FOOD SERVICE PLAN REVIEW

Reviewer: *John Blum* Date: **07/25/2022**

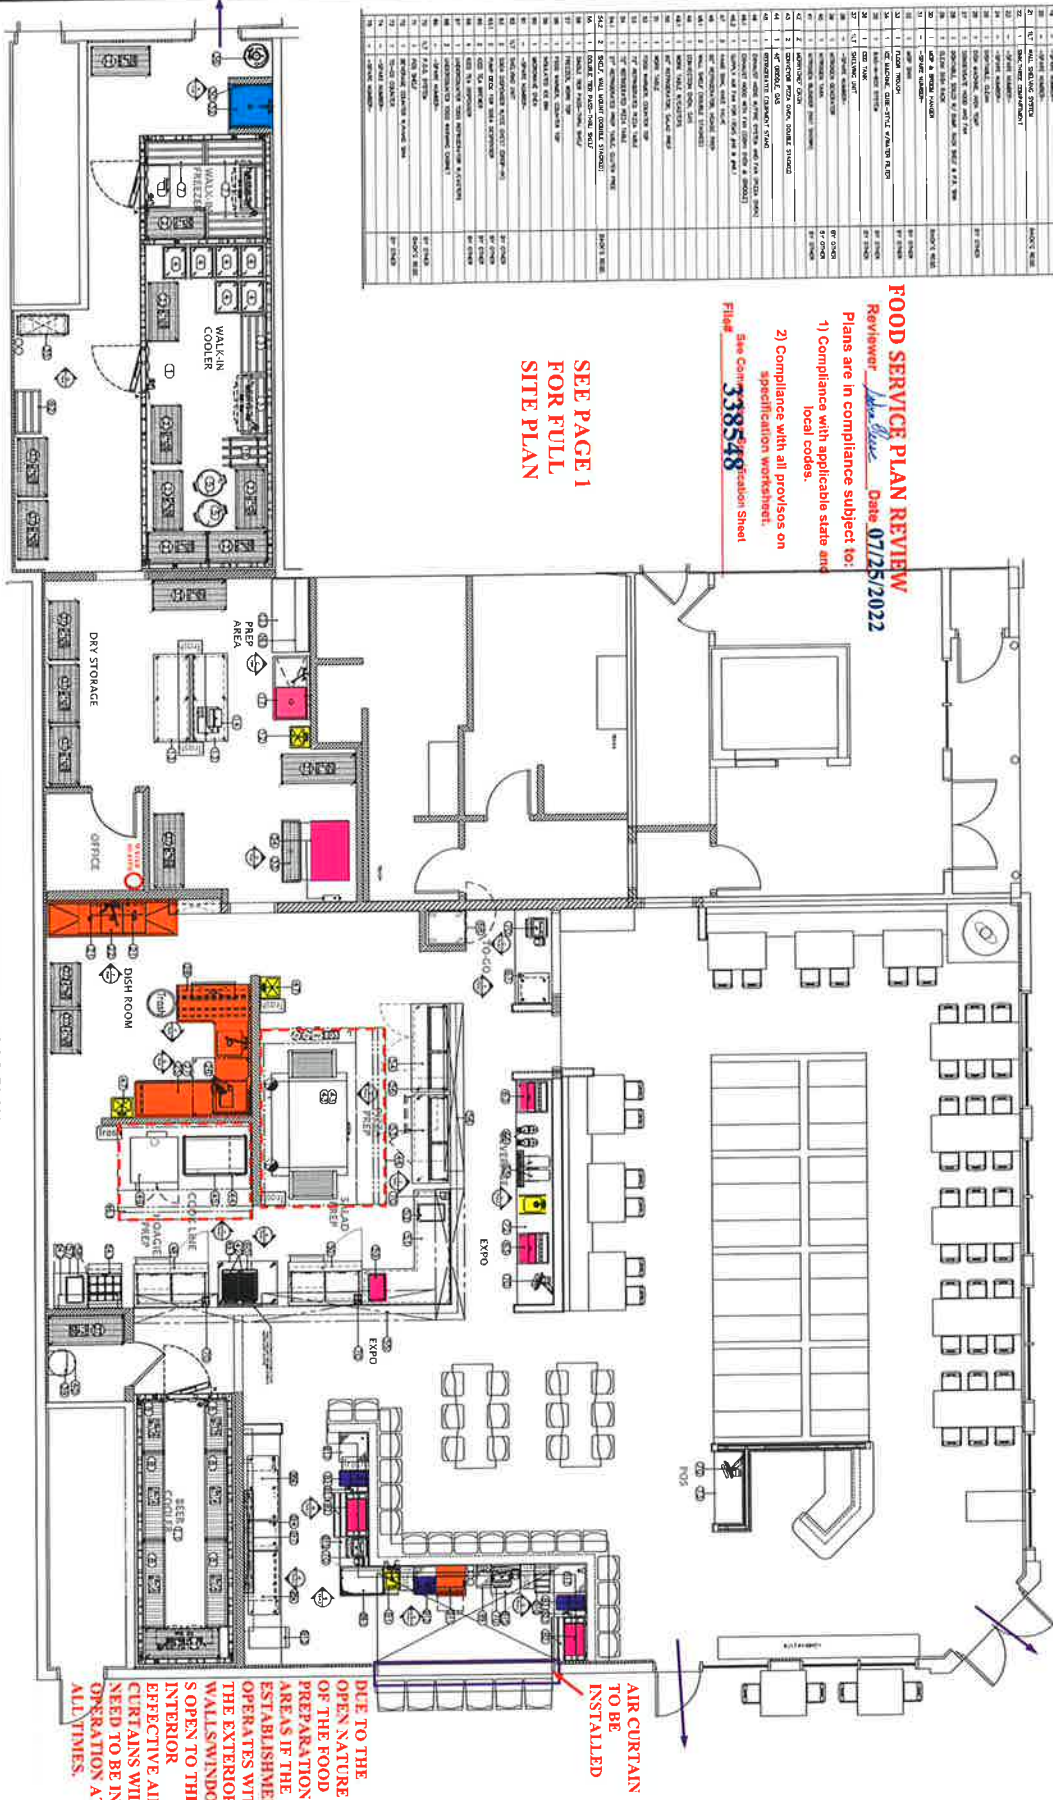
AIR CURTAIN
 TO BE
 INSTALLED

DUE TO THE
 OPEN NATURE
 OF THE ROOD
 PREPARATION
 AREAS IF THE
 ESTABLISHMENT
 OPERATES WITH
 THE EXTERIOR
 WALLS/WINDOWS
 OPEN TO THE
 INTERIOR
 EFFECTIVE AIR
 CURTAINS WILL
 NEED TO BE IN
 OPERATION AT
 ALL TIMES.
